<b>GENERAL ARRANGEMENT 1 OF 3</b>		<b>ROYAL FREE PEARS BUILDING</b>	
PLANNING	1:100 @ A1	30.03.2016	1372-GA-101-10

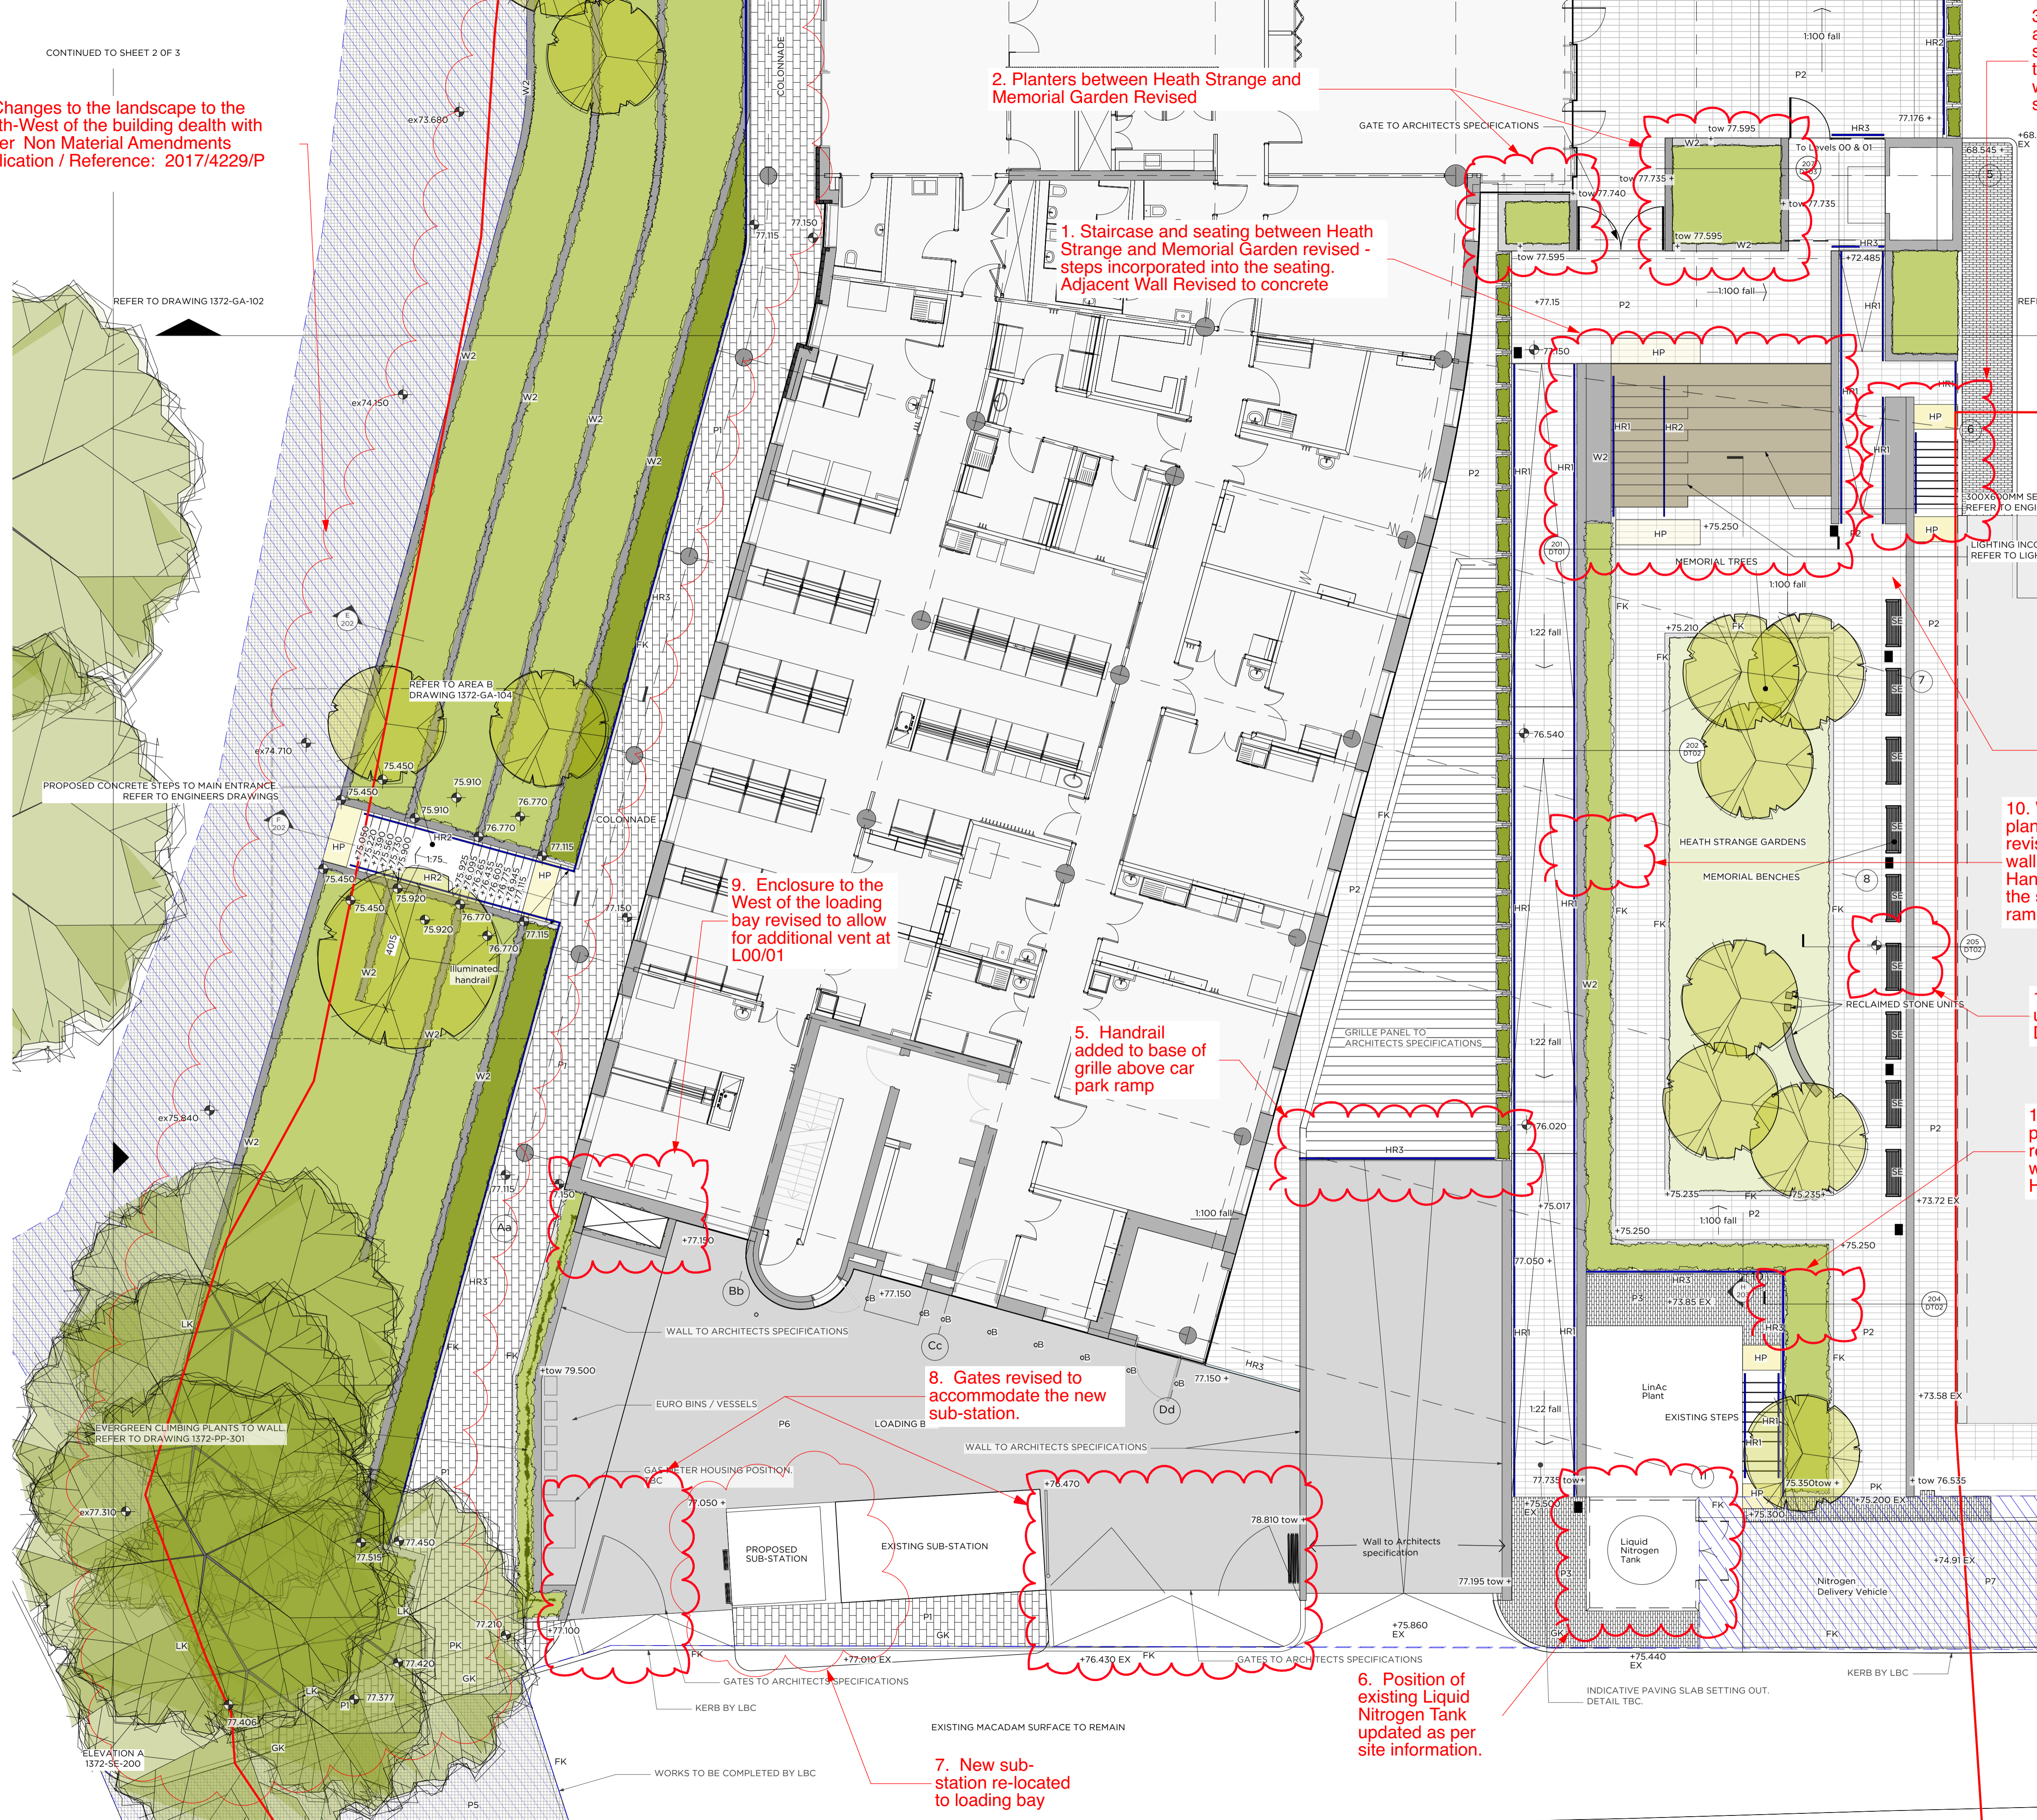
A. Changes to the landscape to the North-West of the building death with under Non Material Amendments application / Reference: 2017/4229/P

2. Planters between Heath Strange and Memorial Garden Revised

1. Staircase and seating between Heath Strange and Memorial Garden revised - steps incorporated into the seating. Adjacent Wall Revised to concrete

3. Planter adjacent to timber seating changed to a concrete wall. Adjacent stair revised

4. One bench omitted

10. Width of planting/path revised. height of wall adjusted. Handrail added to the side of the ramp

13. Height of wall updated. See Detail 2 of 3.

11. Width of planting/path revised. height of wall adjusted. Handrail added.

9. Enclosure to the West of the loading bay revised to allow for additional vent at L00/01

5. Handrail added to base of grille above car park ramp

8. Gates revised to accommodate the new sub-station.

6. Position of existing Liquid Nitrogen Tank updated as per site information.

7. New sub-station re-located to loading bay
